**Atari Technical Bulletin**  
**Number: TT30-0003**  
**Date: March 24, 1992**  
**Page 1 of 2**

Product(s) Affected: TT030  
Model: All  
Type of ATB: As Needed  
ECO #: N/A

To correct improper jumper setting causing coprocessor to run at 16MHz instead of 32MHz.

Figure 1

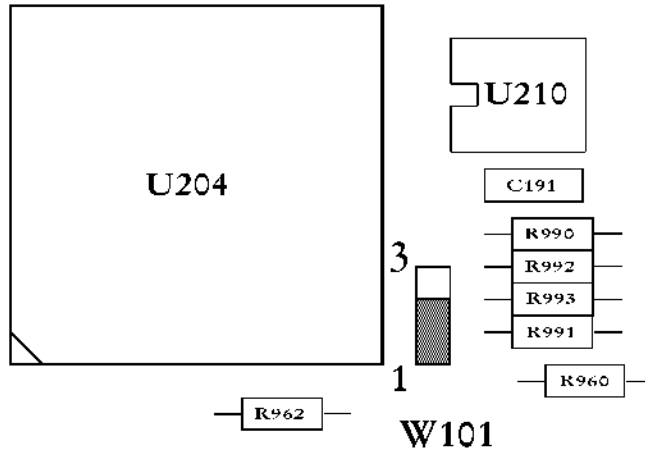
For FAB C301763-001 REV D and C302406-001 REV A see Figure 1 on page 2.

Be sure the jumper is parked across pins 1 and 2.
3. Re-assemble unit.

Figure 2

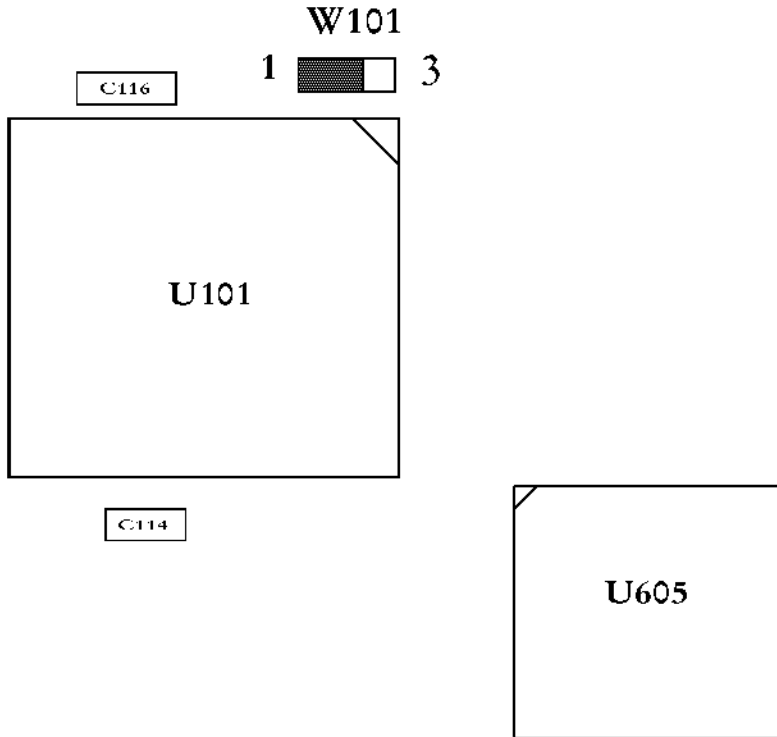
For FAB C301763-001 REV B1 see Figure 2 on page 2.
